July 30, 2015

G-3837

Subject: Response to Geotechnical Third Party Review Comments
Proposed Residence
5637 East Mercer Way
Mercer Island, Washington

Enclosure: City of Mercer Island GIS Mapping Excerpt

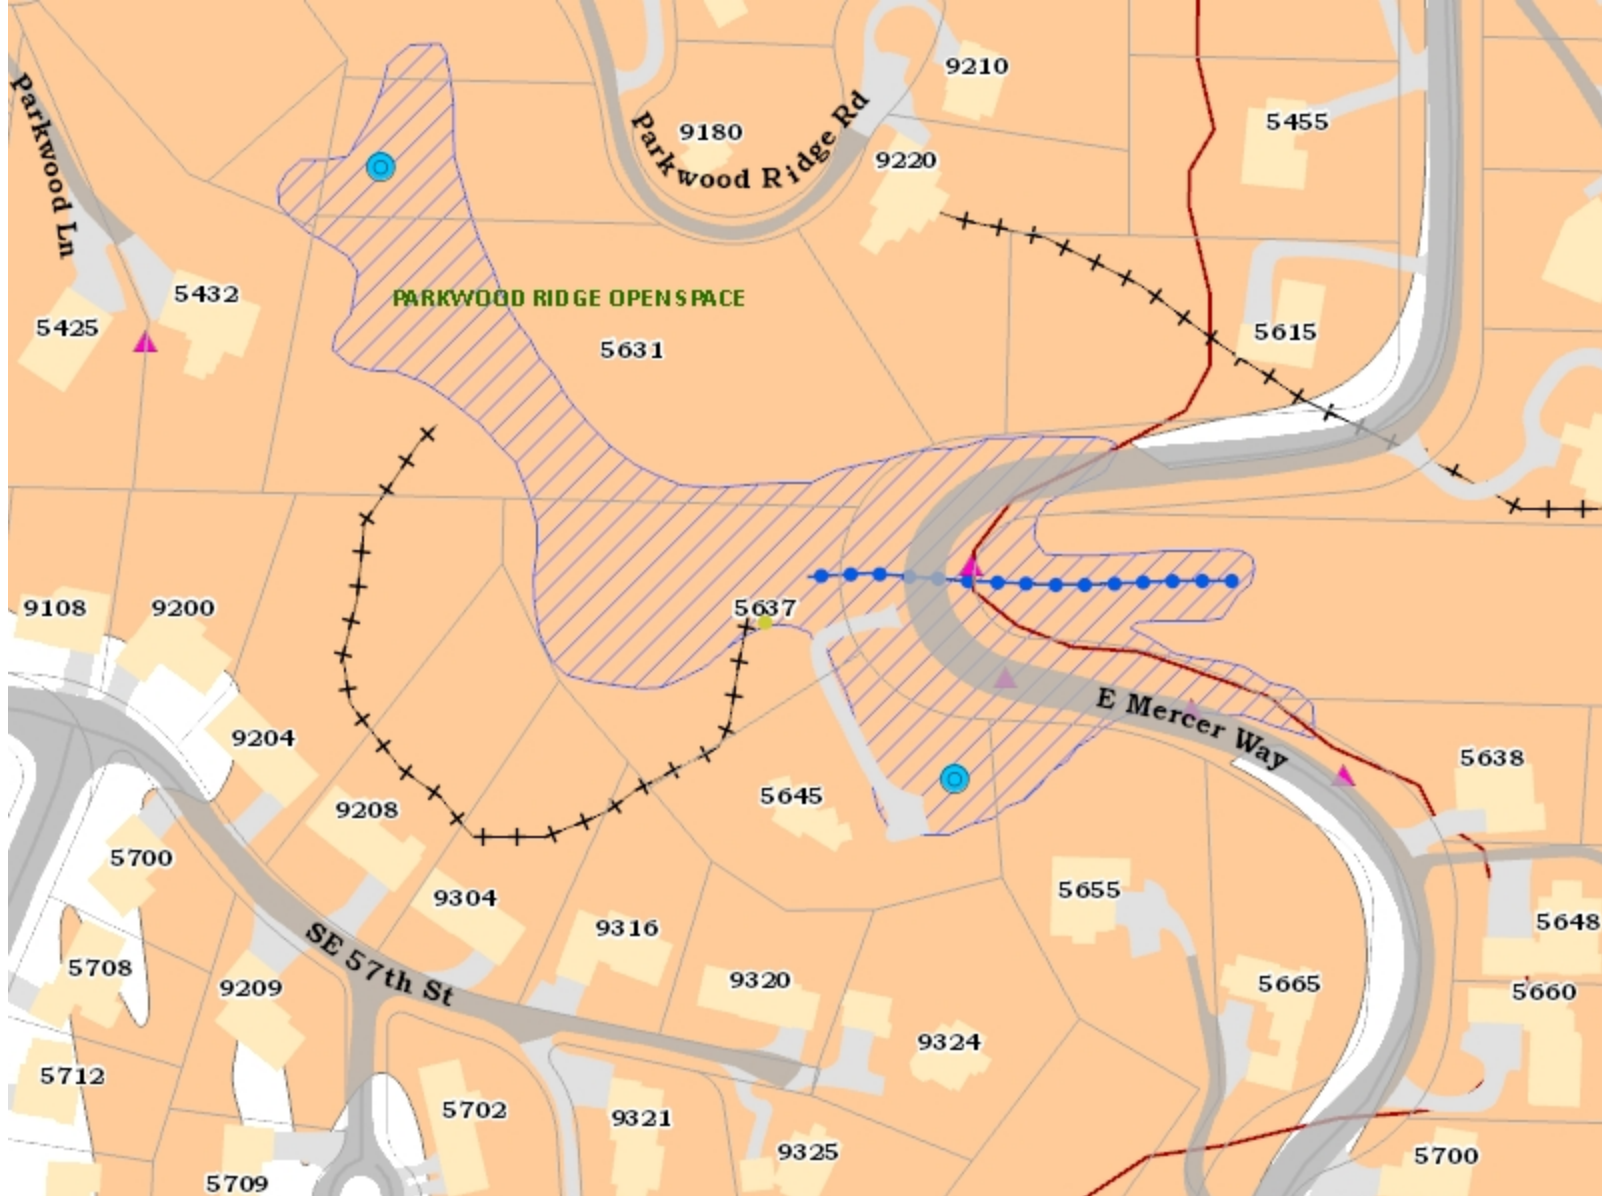
Known landslides, based on mapping retrieved from the City of Mercer Island Information and Geographic Services internet portal, are located along East Mercer Way next to parcels at the addresses of 5645/5655 and 5638. A landslide also is noted at parcels 5425 and 5432 Parkwood Lane located approximately 275 feet north-northwest from the project site. A copy of an excerpt of the mapping is enclosed as Attachment 1.
